# Access Compliance Report

## Public Rights-of-Way

### (Curb Ramps)

Intersection ID: 50928	Main Street: GREAT_FUTURE_DR	Cross Street: MARVIN_RD	Location: W
ADA ID: 2341BEF25DEB	Ramp Type: Perp	Initial Pass/Fail: Fail	Overall Compliance: No
Severity Score: 33.75			
Codes/Mitigation Info/Possible Solution		Field Measurements/Component Compliance

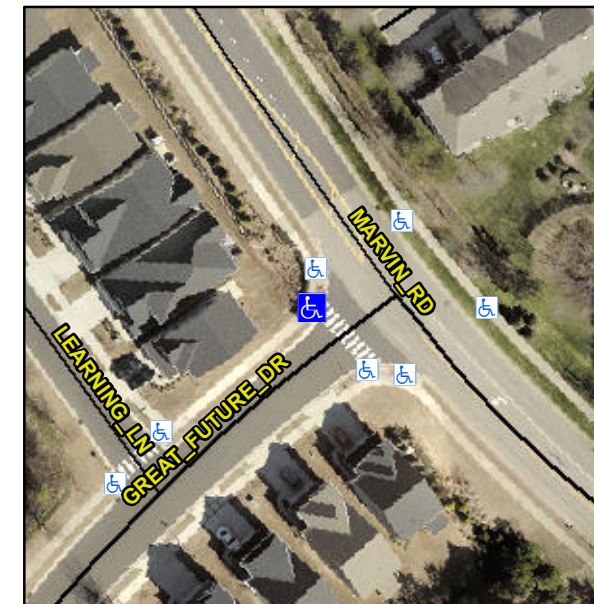
**Not Found, R304.5.1, R304.2.2, R304.5.3**

Compliance	Description	Data	Compliance	Description	Data
N/A	Ramp Length (in)	49.0	No	Ramp Slope (%)	9.5
No	Ramp Width (in)	47.5	No	Ramp XSlope (%)	5.5
N/A	Flare Type LT	N/A	N/A	Flare Type RT	N/A
N/A	Flare Slope LT (%)	N/A	N/A	Flare Slope RT (%)	N/A
N/A	Flare Traversable LT?	N/A	N/A	Flare Traversable RT?	N/A
N/A	Landing Length (in)	N/A	N/A	DWS Provided?	N/A
N/A	Landing Width (in)	N/A	N/A	DWS Contrast?	N/A
N/A	Landing Slope (%)	N/A	N/A	DWS Length (in)	N/A
N/A	Landing X Slope (%)	N/A	N/A	DWS Full Width?	N/A
N/A	Landing Curb? (Y/N)	N/A	N/A	DWS Offset (in)	N/A
N/A	Shared Landing?	N/A			
N/A	Gutter Ponding?	N/A	N/A	Gutter Slope (%)	N/A
N/A	Gutter Lip Ht (in)	N/A	N/A	Gutter X Slope (%)	N/A
N/A	Painted X Walk1?	Yes	N/A	Painted X Walk2?	N/A
	X Walk 1 Direction	To SE		X Walk 2 Direction	N/A
N/A	X Walk 1 Width (in)	120.0	N/A	X Walk 2 Width (in)	N/A
	X Walk 1 Slope (%)	3.2		X Walk 2 Slope (%)	N/A
	X Walk 1 X Slope (%)	2.1		X Walk 2 X Slope (%)	N/A

**Remove & Replace Entire Ramp.**
